# Staff Report

Zoning and Land Regulation Committee

<i>Public Hearing:</i> <b>April 24, 2018</b>	<i>Petition:</i> <b>Petition 11276</b>
<i>Zoning Amendment:</i> <b>RH-1 Rural Homes District TO R-4 Residence District</b>	<i>Town/sect:</i> <b>VERONA, Section 36</b>
<i>Acres:</i> 40.1 <i>Survey Req. No</i>	<i>Applicant</i> <b>STEVEN P REINEN</b>
<i>Reason:</i> <b>Proposed 16-unit condominium for single-family residential development</b>	<i>Location:</i> <b>NORTH AND WEST OF 6440 SUNSET DRIVE</b>

# Dear Haven Slopes

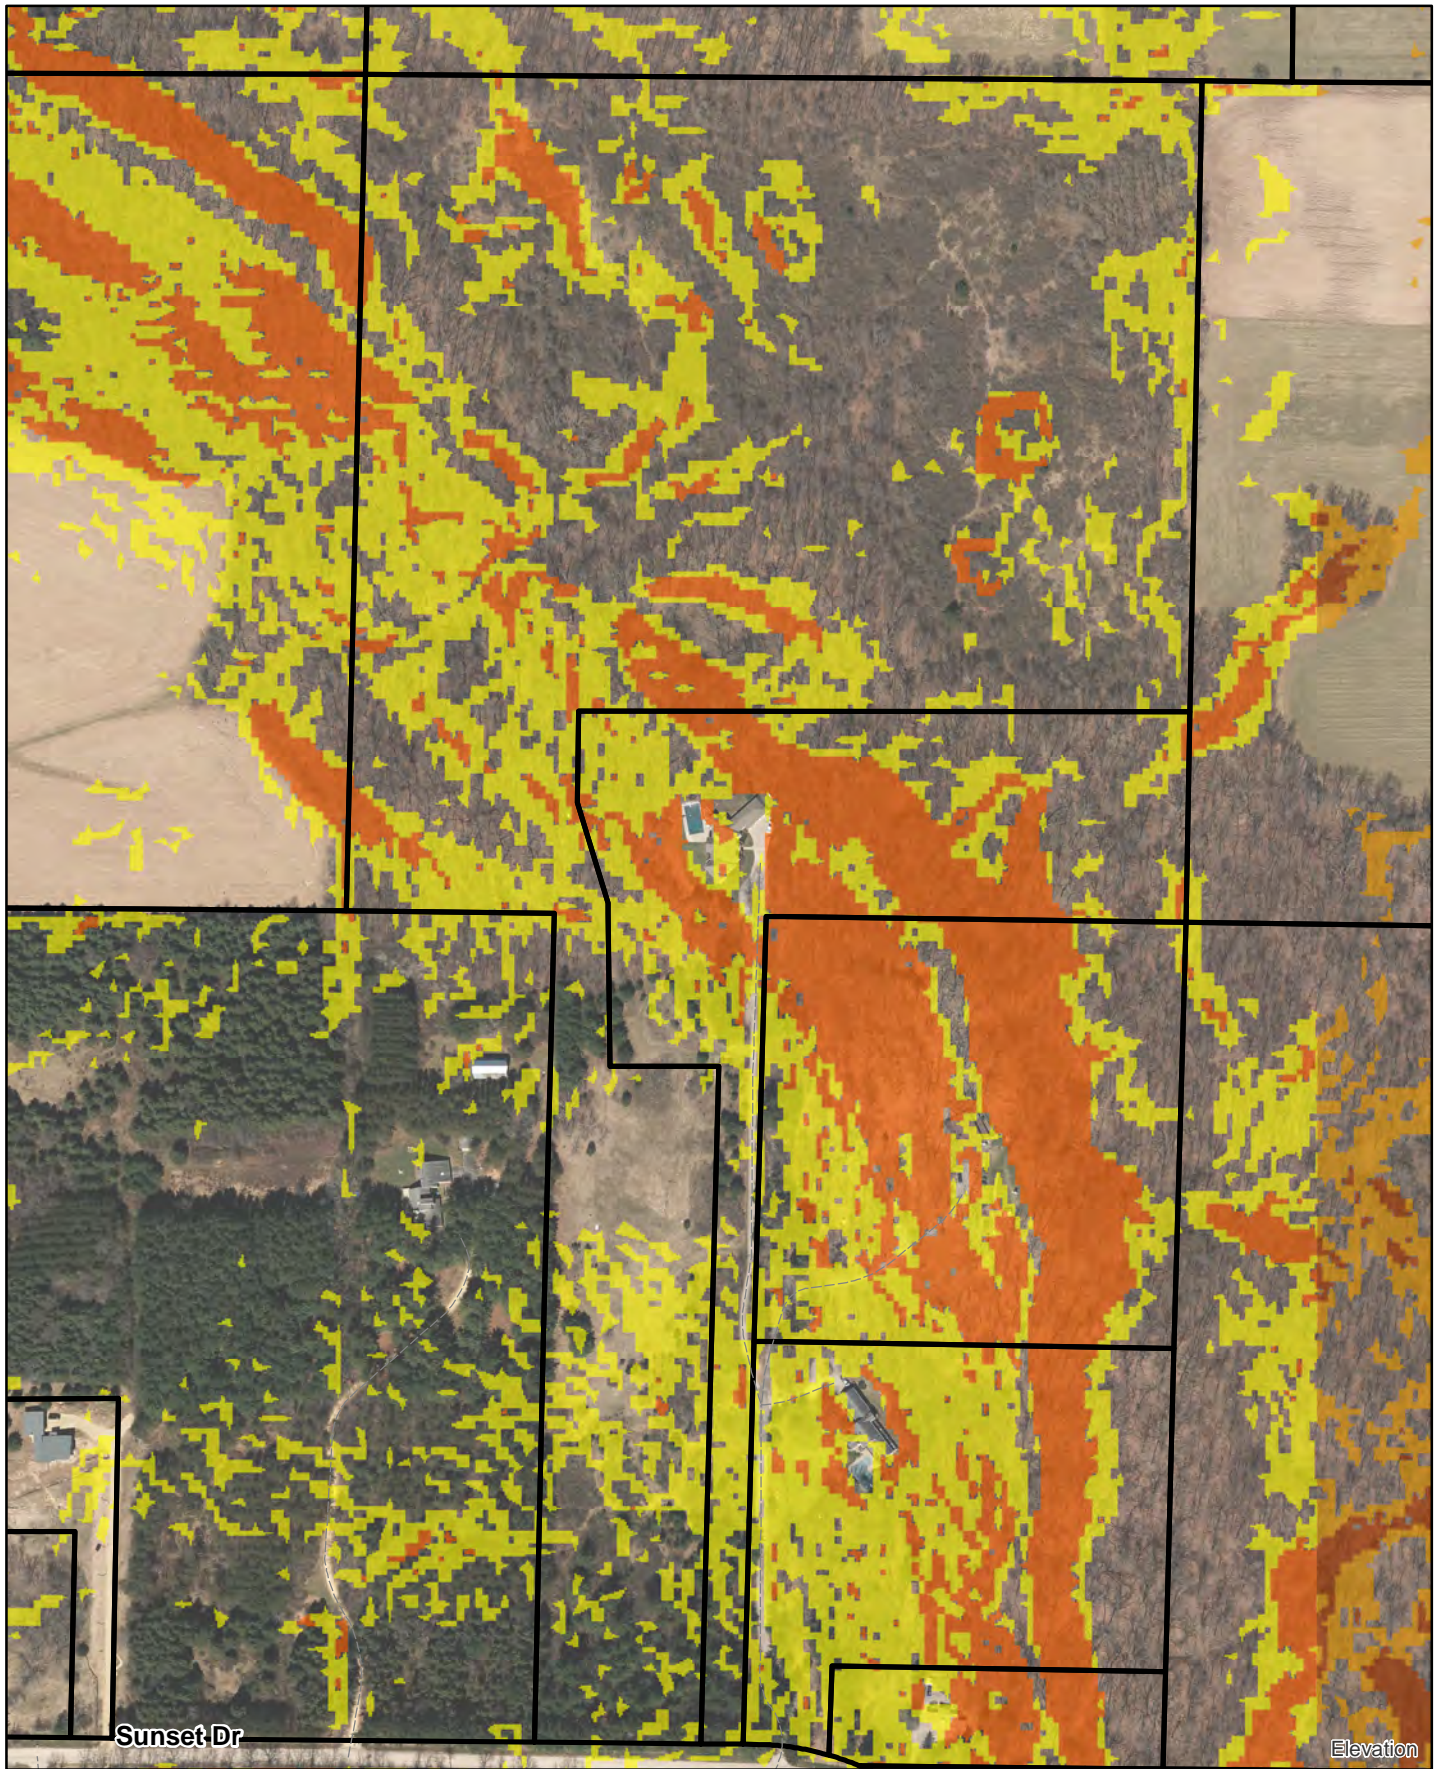
The Zoning and Land Regulation Committee postponed action on the petition due to public opposition. Rosemary Bodolay stated that she was concerned about development on steep slopes, protection of the woodland, some of the lots not being 1.5 acres and conflicting with Town policies, and the increased traffic on Sunset Drive which is a bike conduit. Hans Pigorsch stated that the development was too dense and the increased traffic due to the development would be a danger to bike traffic. Susan Pigorsch stated that she was concerned about development on steep slopes and was concerned about proper storm water management. Mark Singel stated that the development was too dense, future home owners may trespass onto his property, and that the unique features of the land (woods and kettles) may be destroyed as part of the development.

The steep slope topography is found on the west sided of the property. See attached map. This area is primary designated as “common area” which will not be developed. The building envelope areas have been designed outside the steep slope areas. The old growth trees are also within the “common area” and will be preserved. There is also selective cutting requirement within the building area as controlled by the condominium documents.
